Product Change Notification: PCN-23-179533

Finger protection cap

HVP-HD1000 Finger Protection Cap EC

EC on 180D header

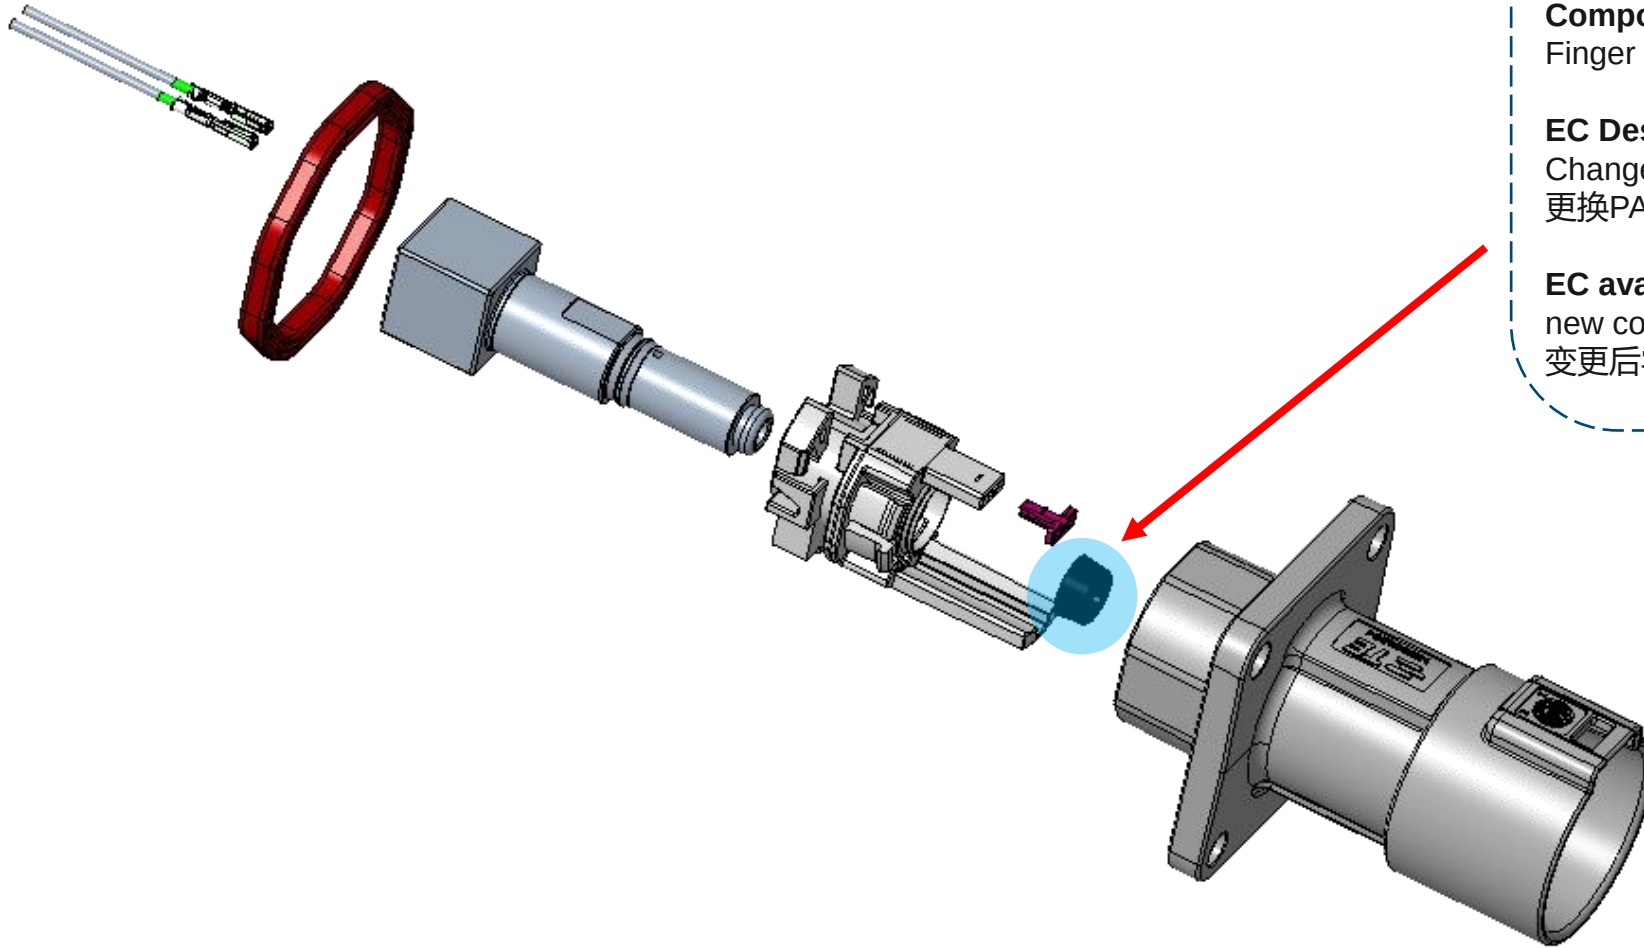
EC Description 变更说明

Change material from PA66-GF to PA66
更换PA66-GF材料为PA66

EC available date 变更实施日期

new component will be available in AUG 2023
变更后零件会在2023年8月份导入.

EC on 90D header

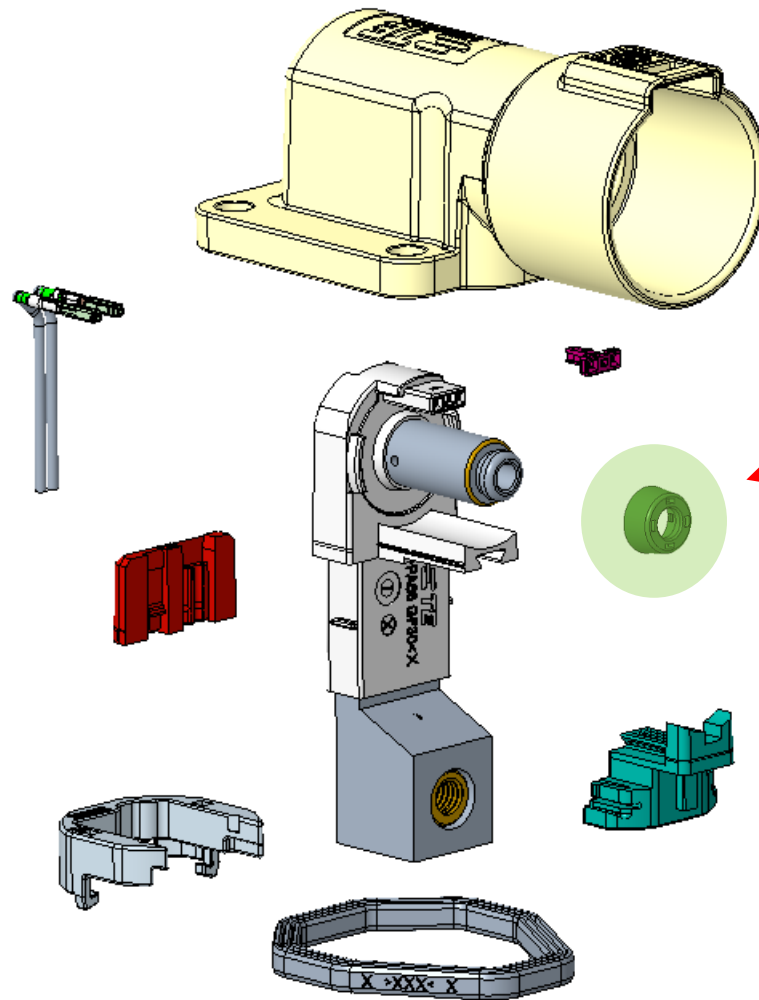
EC Description 变更说明

Change material from PA66-GF to PA66
更换PA66-GF材料为PA66

EC available date 变更实施日期

new component will be available in AUG 2023
变更后零件会在2023年8月份导入.
